Report on the Edgewater
to
The City of Madison Plan Commission

The Mansion Hill Steering Committee on the Edgewater
February 4, 2010

RE: Edgewater

The Roof Deck

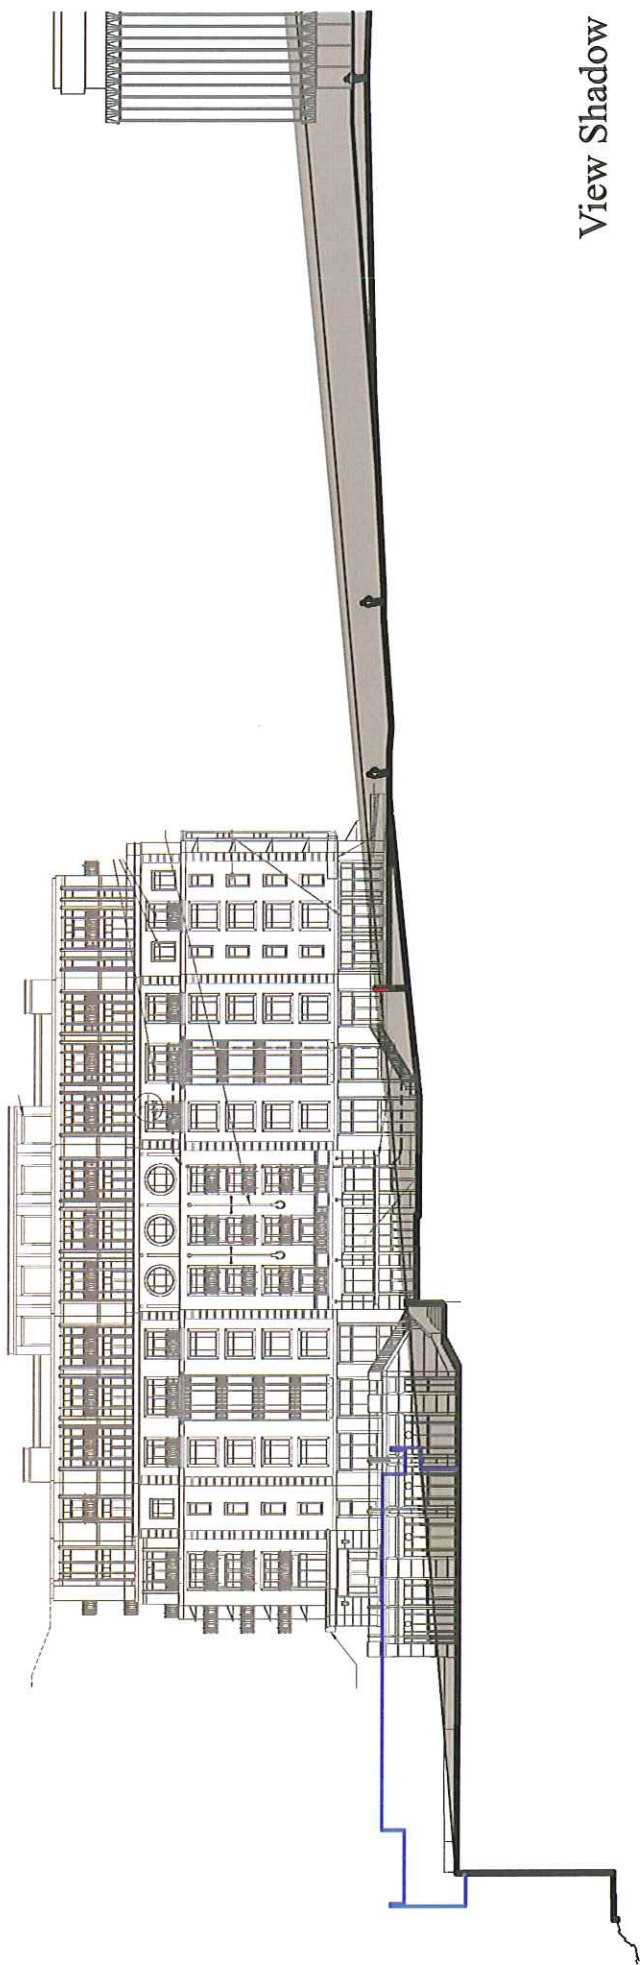
Given the absence of pedestrian traffic in the vicinity and peoples' natural inclination to mingle with other people it would be extremely difficult to draw someone away from State Street or the Union to a unproven, unpopulated new location.

The current design illustrates a nicely detailed and decorated the roof deck but fails to note that it will be completely hidden from Langdon Street, Wisconsin Avenue or any other location in the City except from portions of the Edgewater, One Langdon and Two Langdon. The tiered two-story tall parking structure between street and deck simply

This is a correctable flaw but as presented the roof deck will be completely hidden from view and "Out of sight is out of mind". The public benefit promised can not be delivered.

View Gained
Demolition of 70's Addition

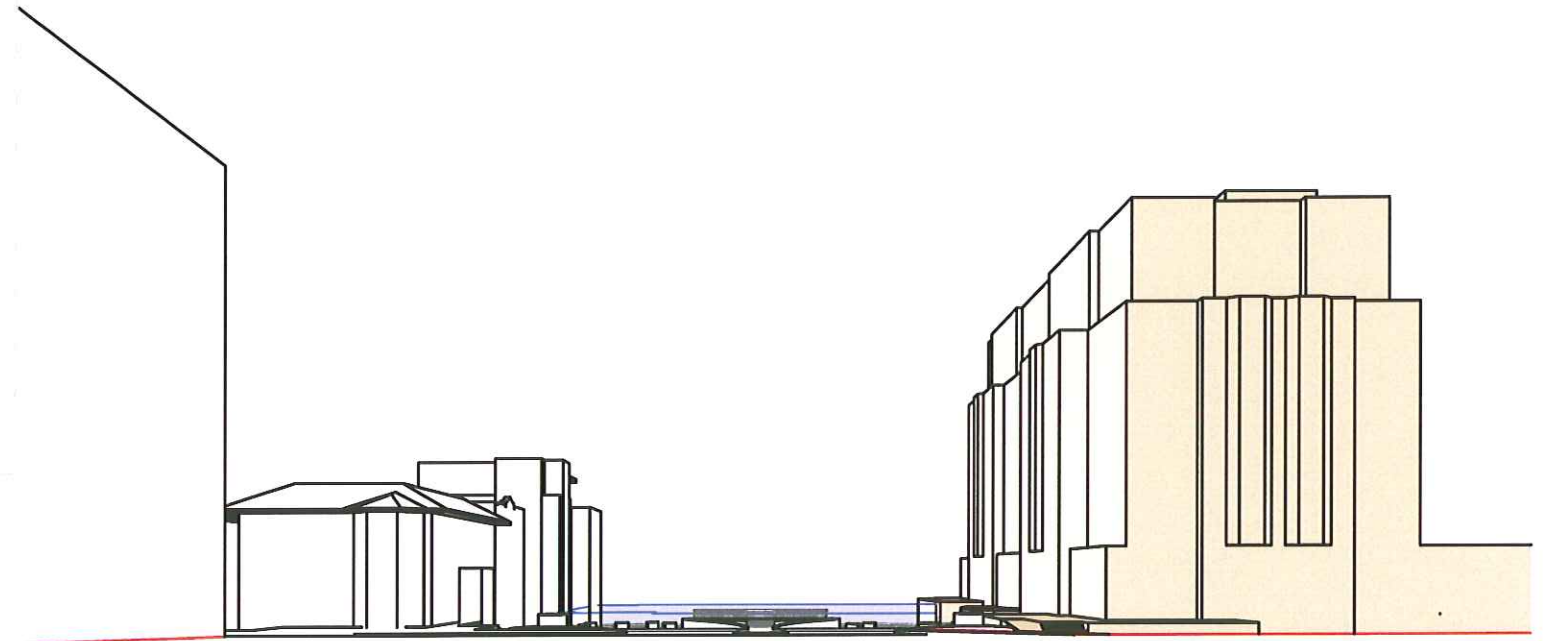
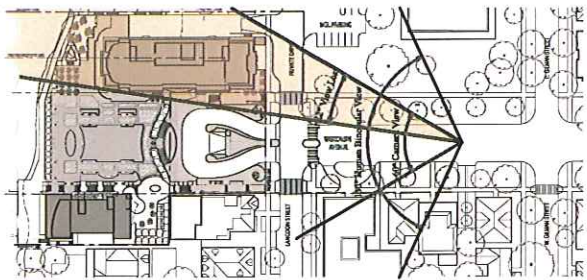
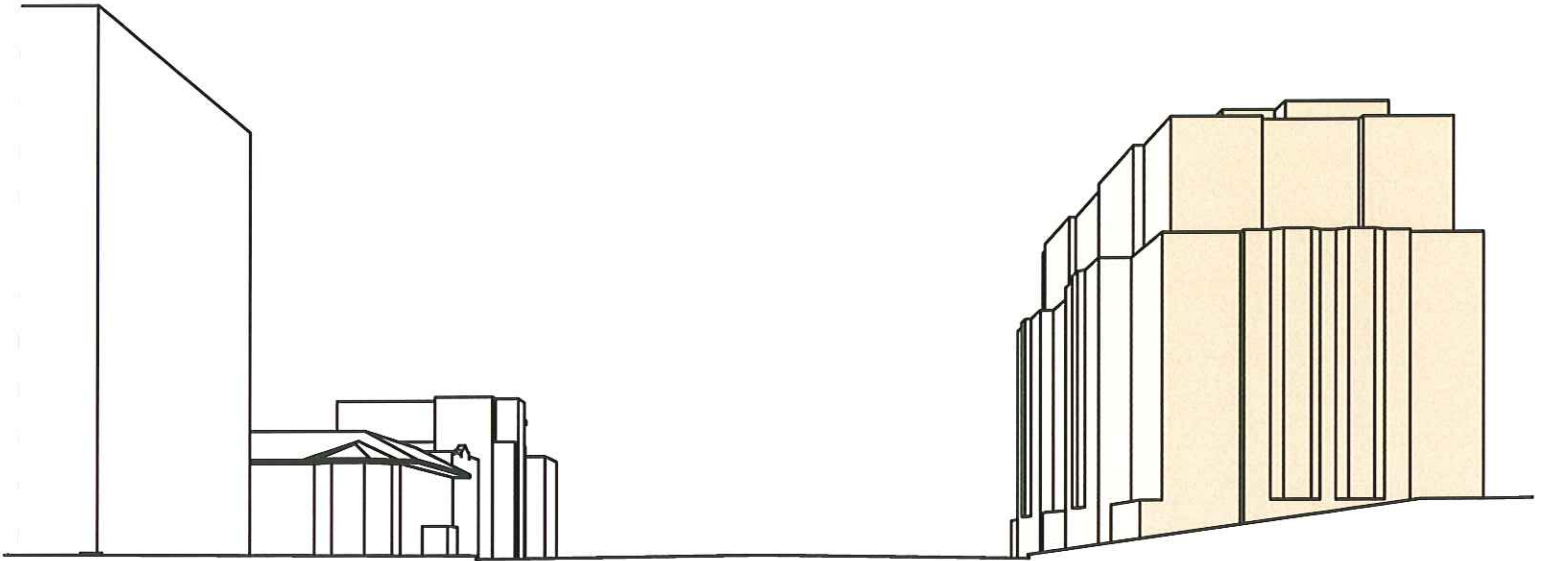
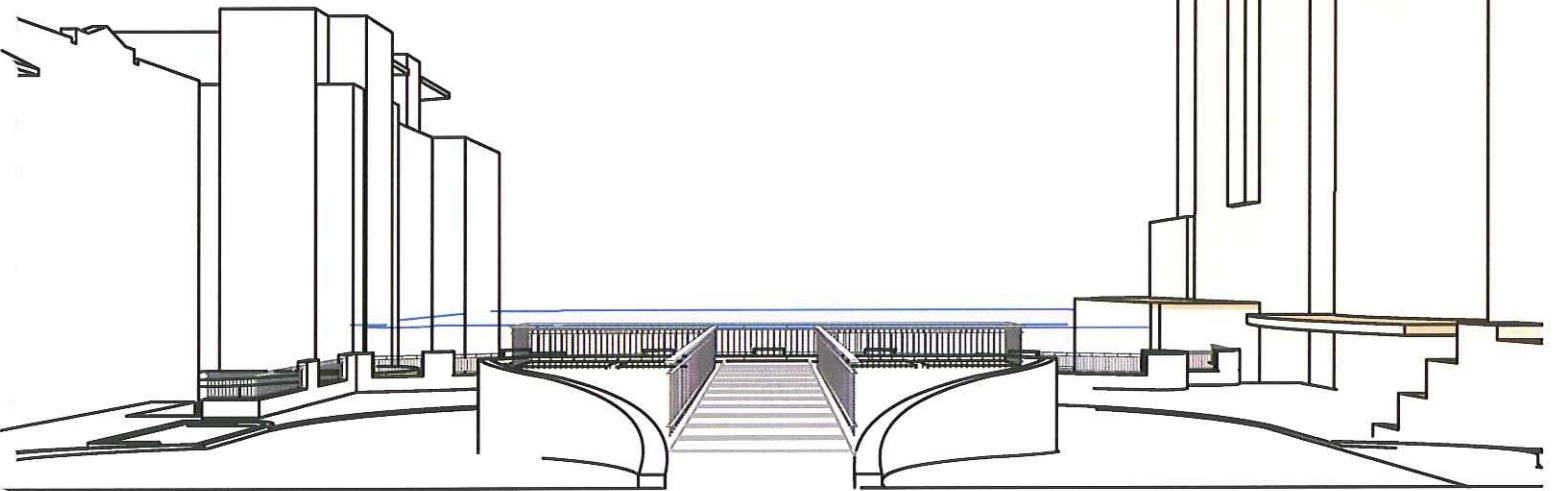
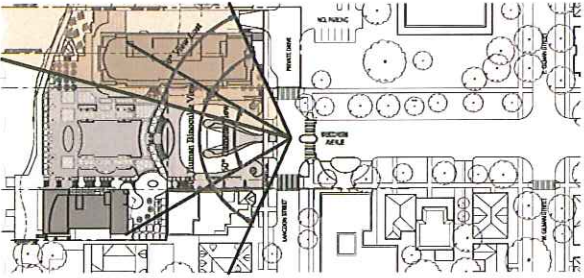
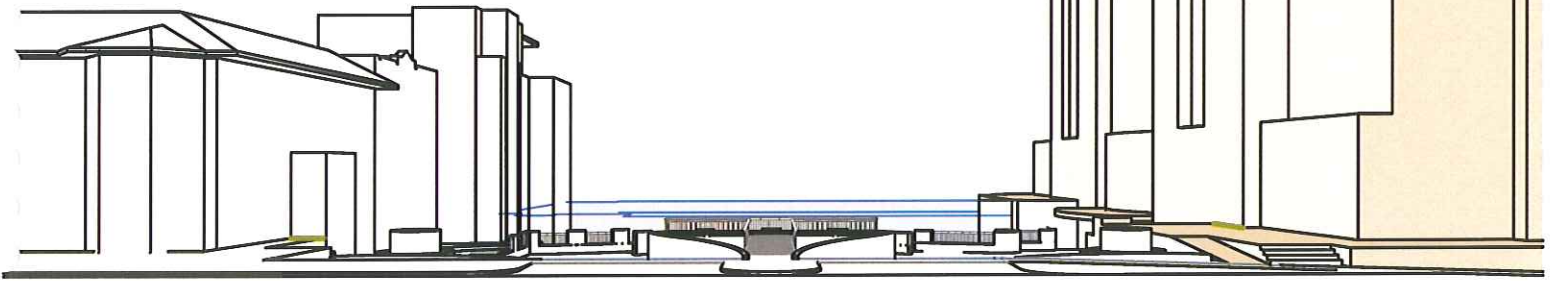
The removal of the 70's addition has been presented as providing an opportunity for opening up the view of the lake from the end of Wisconsin Avenue.

Unfortunately the location and configuration of the parking structure blocks much of the view gained from the demolition.

The structure as designed largely obscures both the stair down to the lake and the lower levels of the newly restored original Edgewater building and blocks from view the entire roof deck,

In return for additional glimmer of lake that will be seen from a two hundred foot stretch on one block we are being asked to accept a massive new tower built tight to the right of way in the middle of an historic district that will be seen for miles and intrude on the view shed for the full length of Wisconsin.

View of the Stair from southwestern of Langdon and Wisconsin

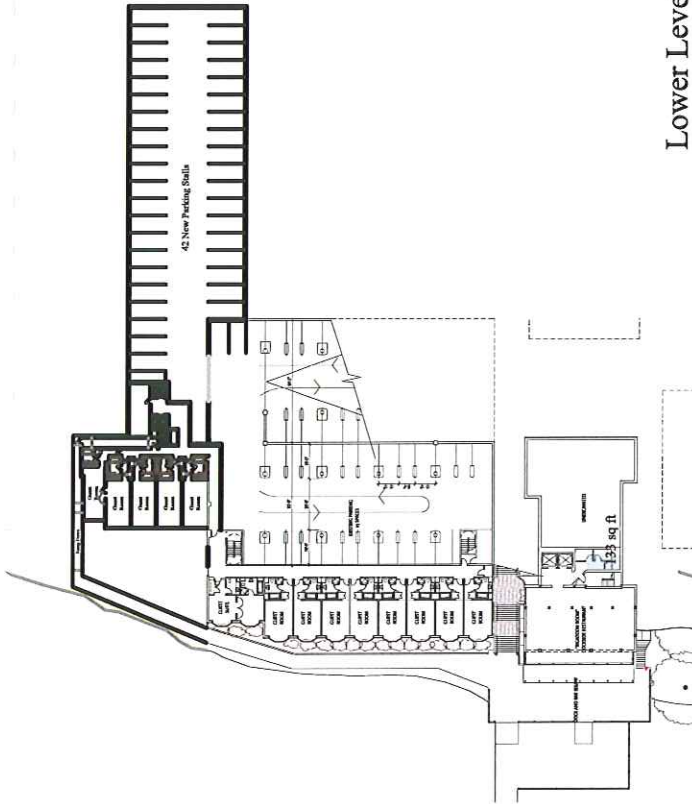
The existing stair from Langdon to the hotel for all its lack of charm follows the contours of the hillside and thus plainly visible. It is also of manageable length and its terminus is in plain sight. The limited number of patrons that enter and leave the hotel on foot clearly favor the stair walk.

With its sixty foot, 116 step, six plus story height this particular stair presents an intimidating challenge to fitness level of a substantial portion of the population and will require a discomfoting level of exertion for most people. Few will attempt it and even fewer will use it twice.

Mansion Hill is not without lake access. Lake & Frances Streets end at the lake edge and there are short manageable stairs to the shore in place at ends of Henry, Carroll & Pinckney Streets. In addition the UW Lifesaving Station at 144 East Gilman offers both a stair down to the Lake and a rooftop-viewing plaza.

Historic and Proposed Views
February 1, 2010

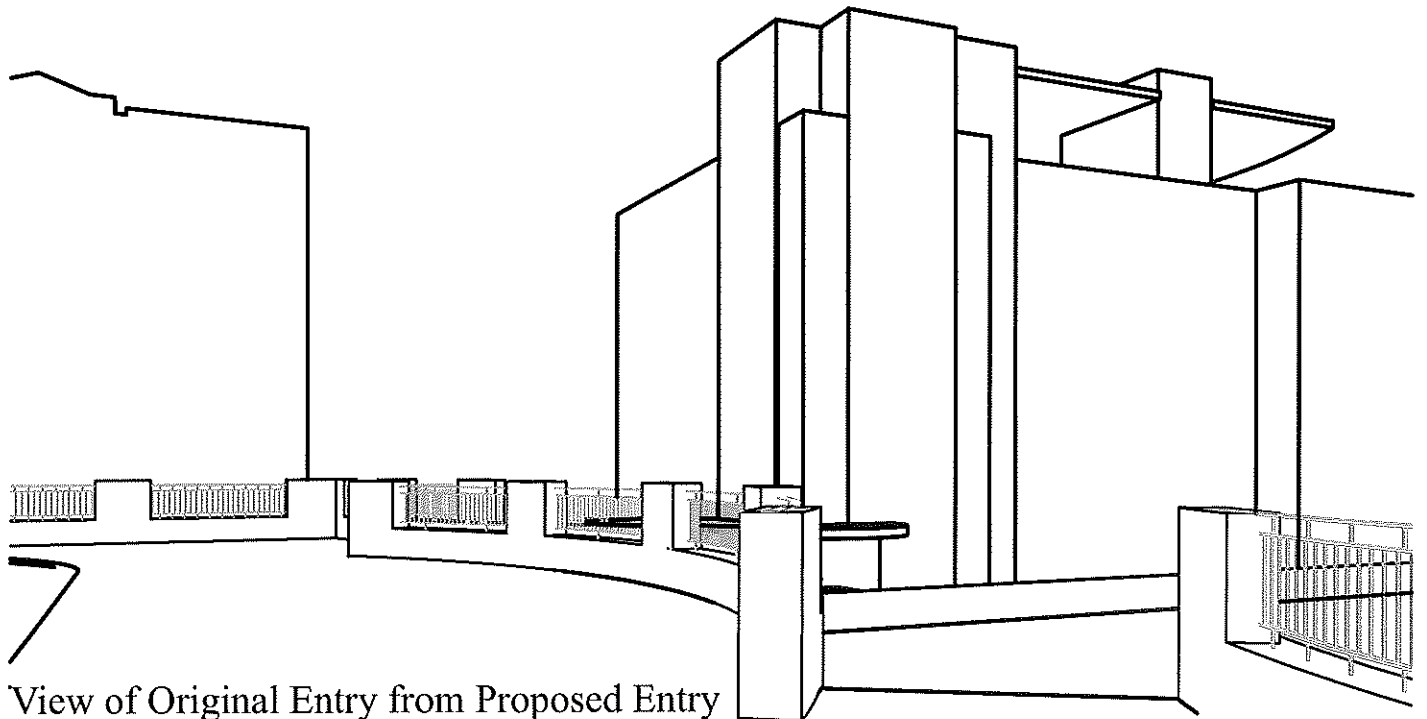
It is no small matter that the original hotel will be sstraightjacketed with a deck and addition constructed in a manner that would have been considered mind numbingly static and stultifying moribund sixty years ago. It is bad enough that the surroundings will be physically overwhelming and of a style antithetical to that of the original but its connection to the street will be physically severed. The new entry will be an empty meaningless "Entry from Nowhere". To compound matters further the location and configuration of the parking structure will effectively obscure the proposed renovations and improvements not only from the street but also from the Edgewater's grand new entry.

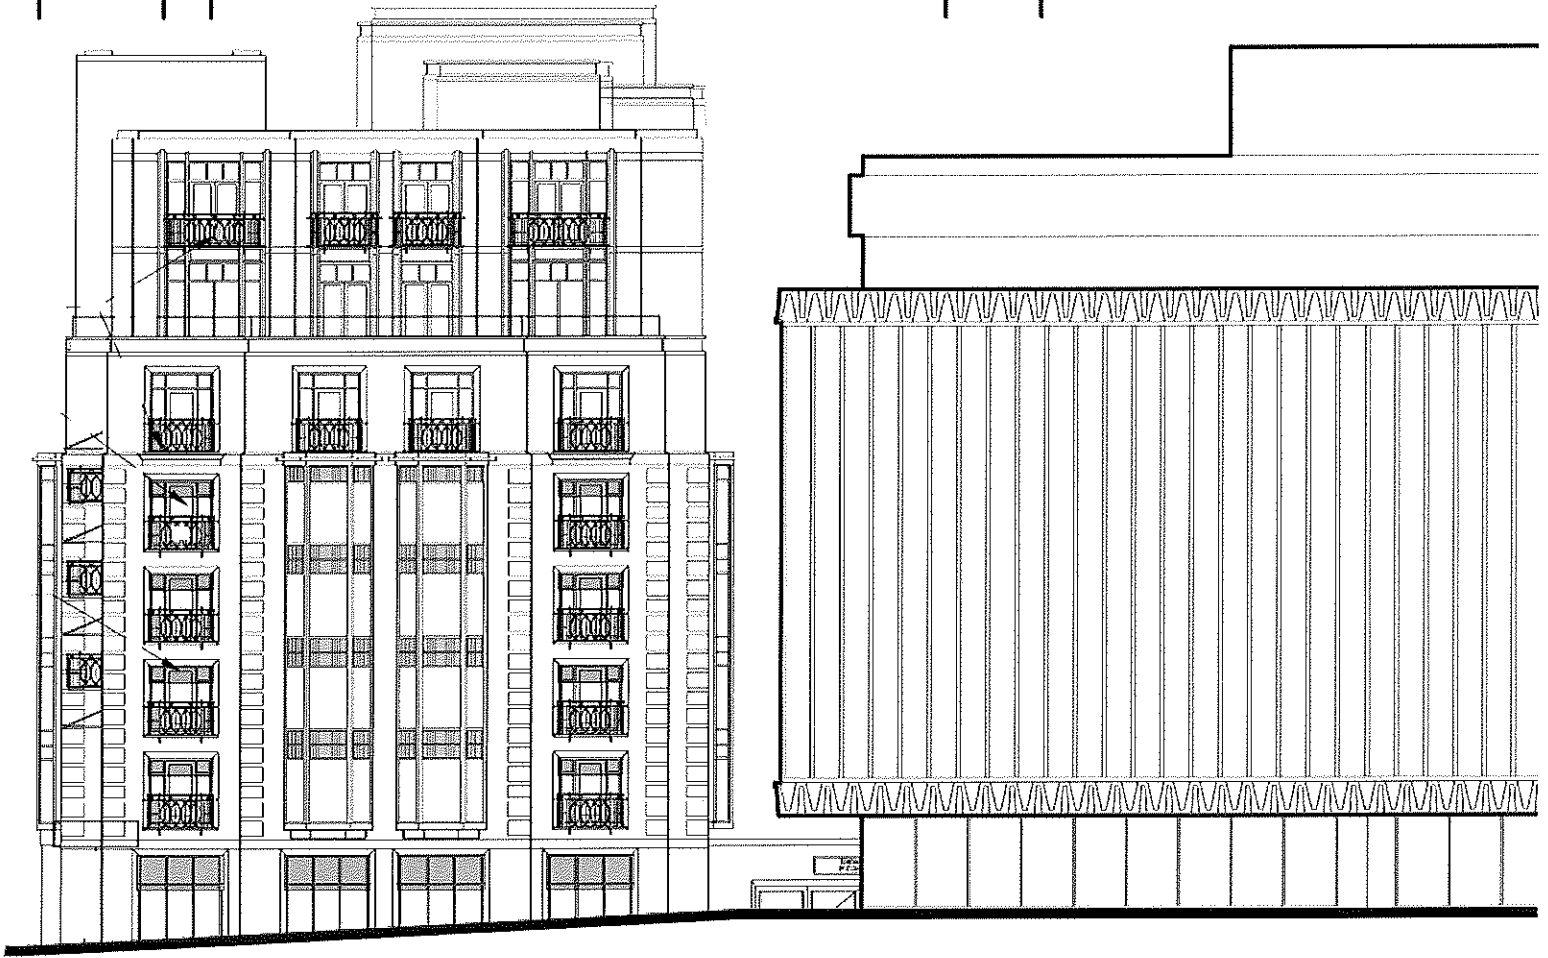
From the perspective of the larger urban context there is no issue more important maintaining the long established shared common setback and the preservation of the view corridor that Madison has kept in trust for 174 years.

The portion of the National Guardian site allocated for the expansion is 105'-4" wide and the tower as proposed is 70'-4" wide. The building can be shifted back 35'.

Wisconsin Avenue Facade Comparison @ 1" = 30'
 The Masonic Temple - Quisling Towers
 December 9, 2009

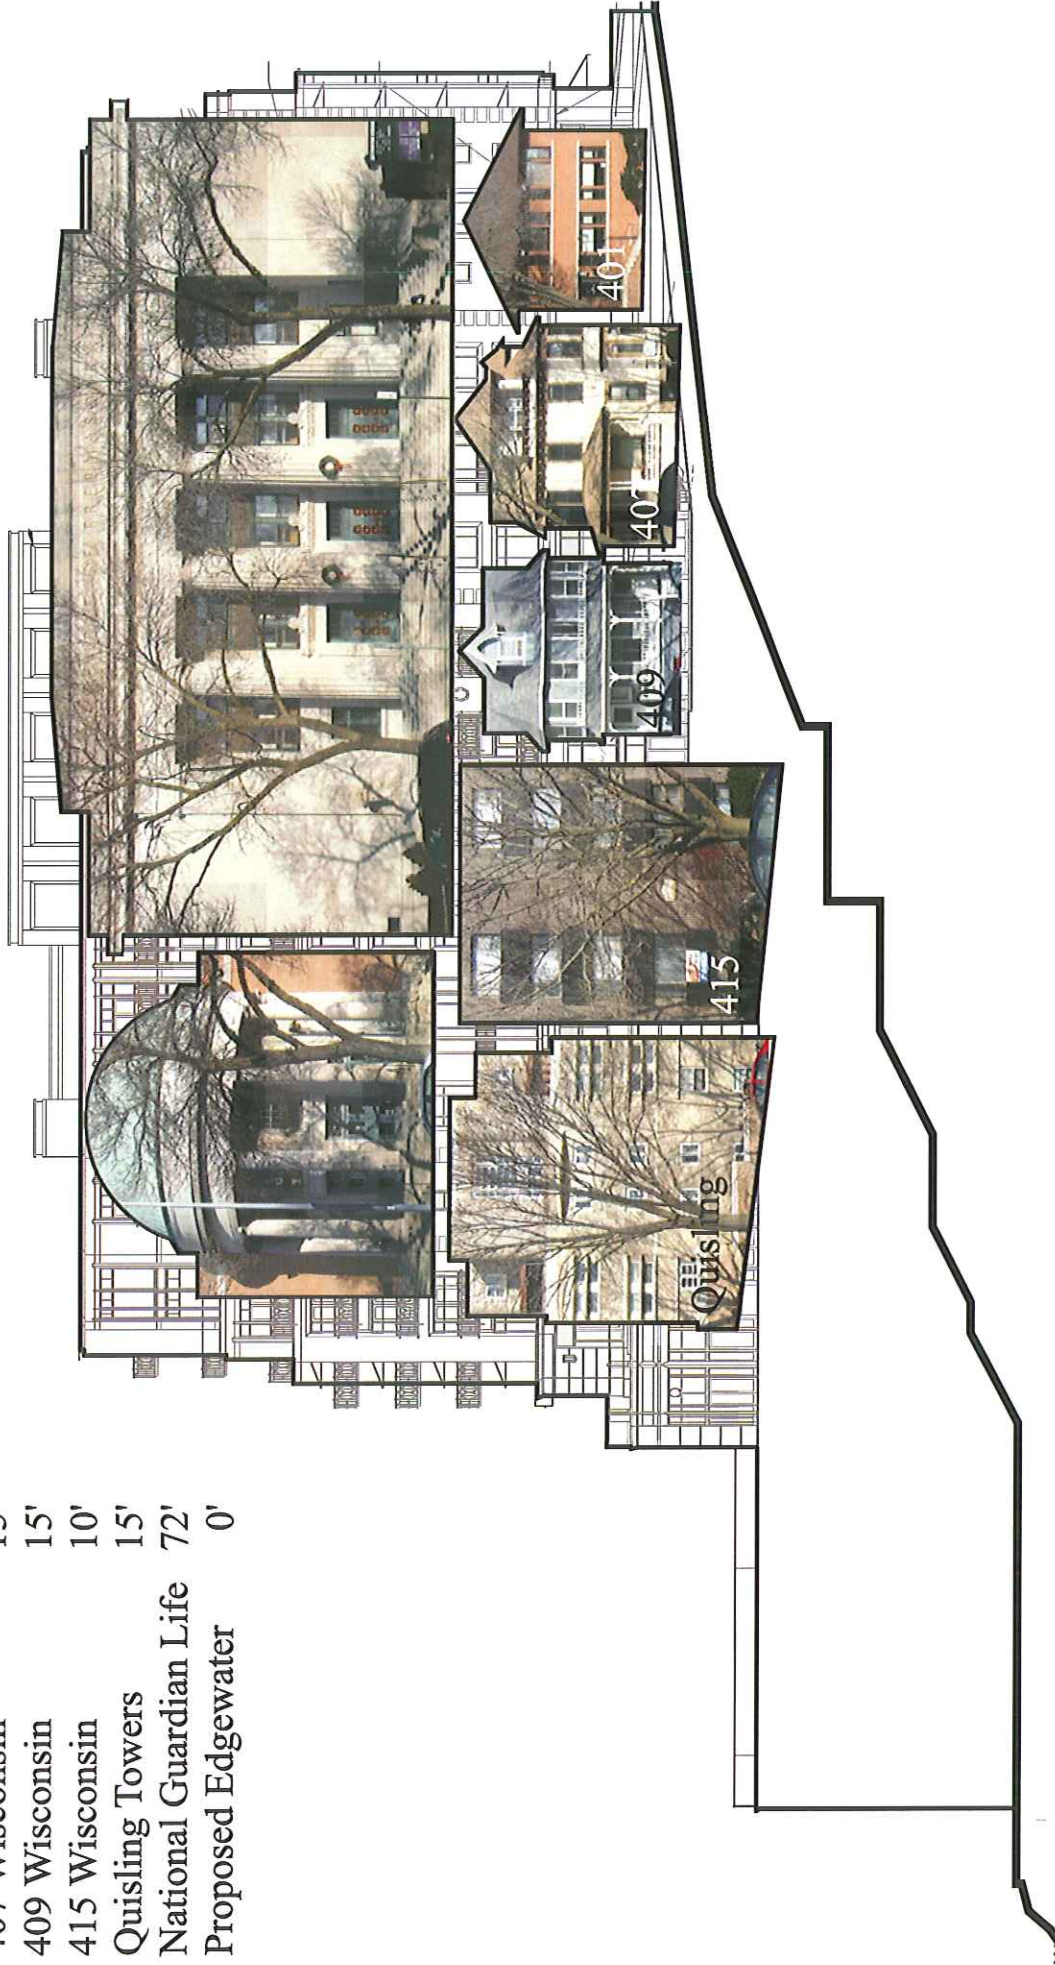
Wisconsin Avenue Setbacks

The Masonic Temple	18'
Christ Scientist	15'
401 Wisconsin	8'
407 Wisconsin	15'
409 Wisconsin	15'
415 Wisconsin	10'
Quisling Towers	15'
National Guardian Life	72'
Proposed Edgewater	0'
